SUBJECT: CHANGES TO TECHNICAL SPECIFICATIONS TO INCREASE MAXIMUM CONCENTRATION
OF SODIUM PENTABORATE (TAC NOS. 65157 AND 65158)

RE: SUSQUEHANNA STEAM ELECTRIC STATION, UNITS 1 AND 2

These amendments revise the SSES Unit 1 and Unit 2 Technical Specifications with regard to Sodium Pentaborate concentration in the Standby Liquid Control system.

Figure 3.1.5-1

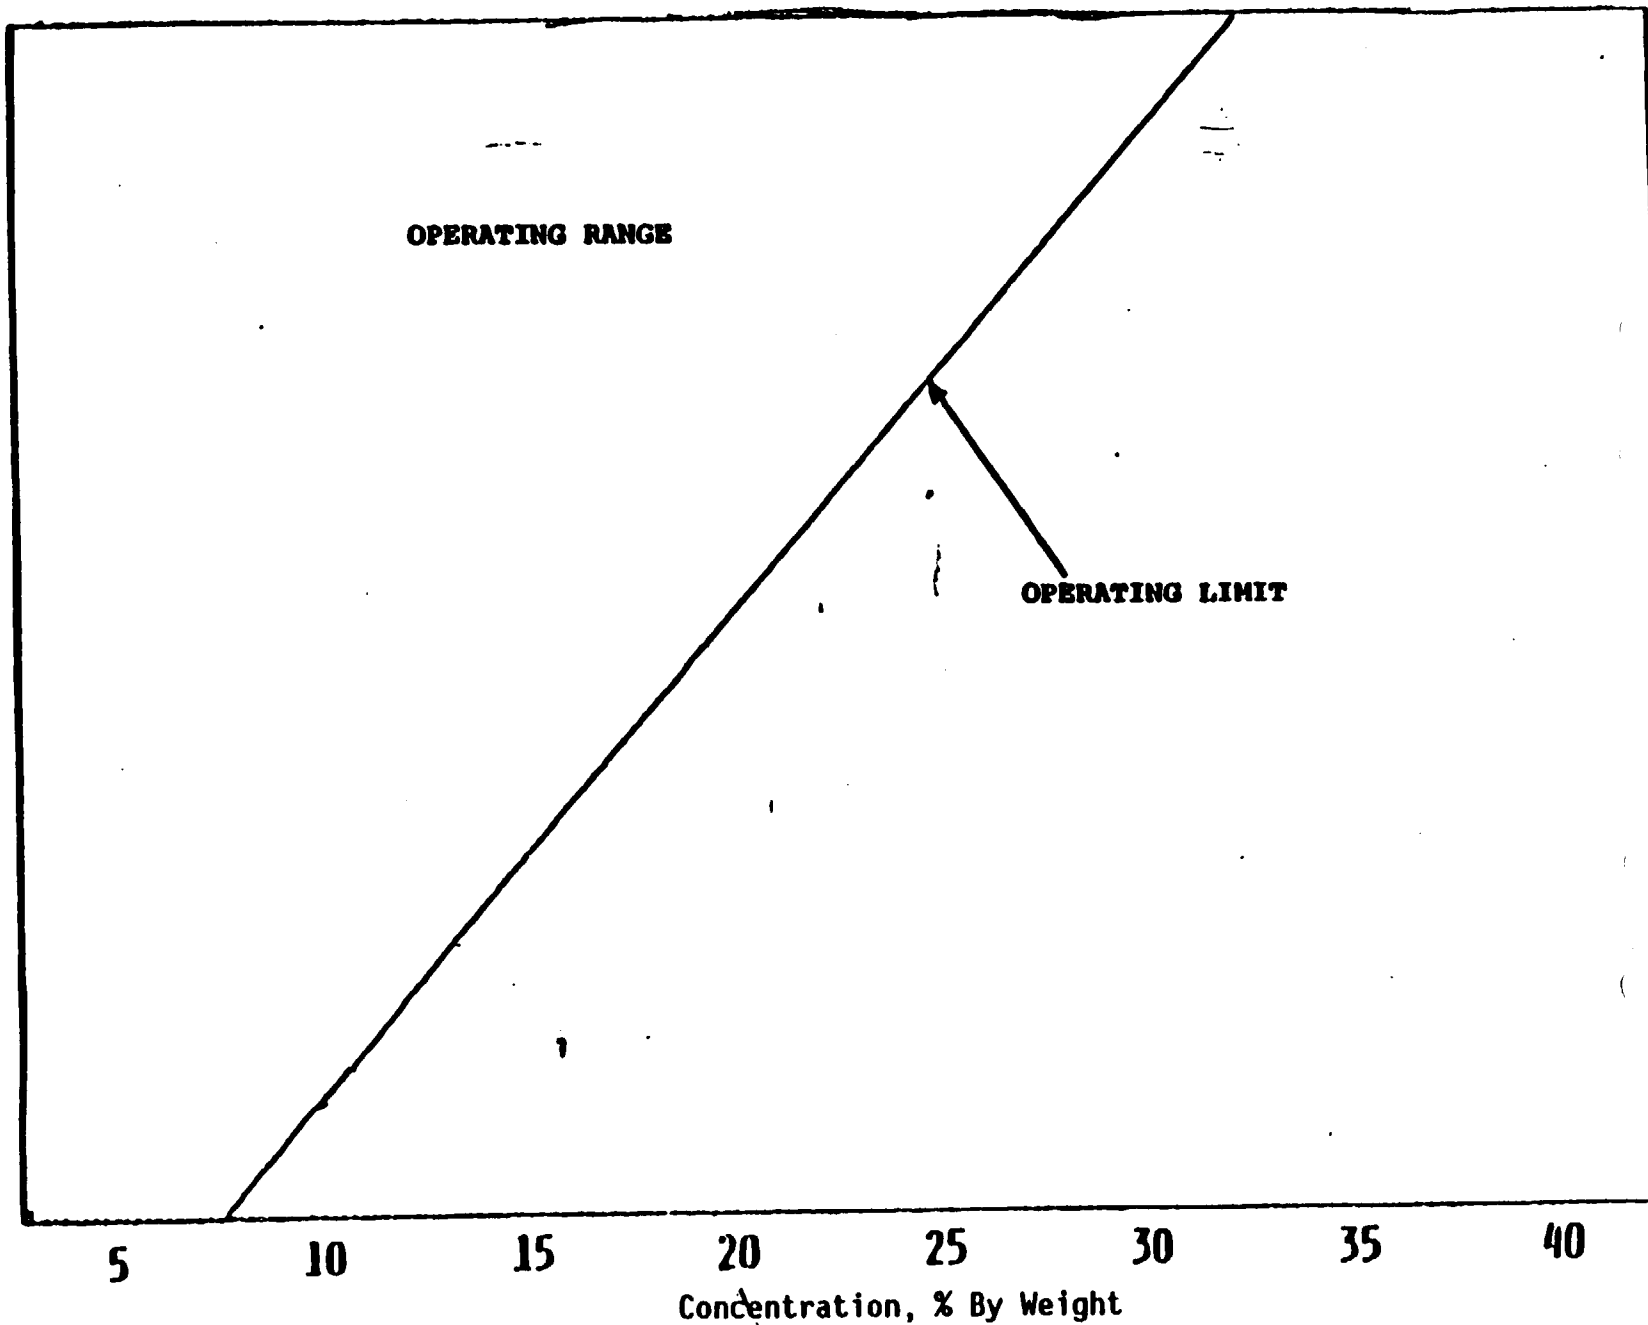
In order to change the TS maximum allowable sodium pentaborate solution concentration for the SLCS from 13.8 weight percent to 15.8 weight percent to increase the band of design margin for the SLCS concentration, the licensee proposed to raise the piping heat trace setting from 80°F to 90°F. This will account for the increase in saturation temperature of the solution from 59°F at a concentration of 13.8 percent (current value) to 70°F at a concentration of 15.8 percent while maintaining a margin of at least 10°F. The margin is reflected in the solution temperature versus concentration curve. The licensee has also stated in a telecon that a heat trace trouble alarm is located in the main control room to alert operators to low temperature conditions which could lead to precipitation of the poison. The staff finds that the proposed change is consistent with the guideline given in the staff's standard review plan, and is, therefore, acceptable.
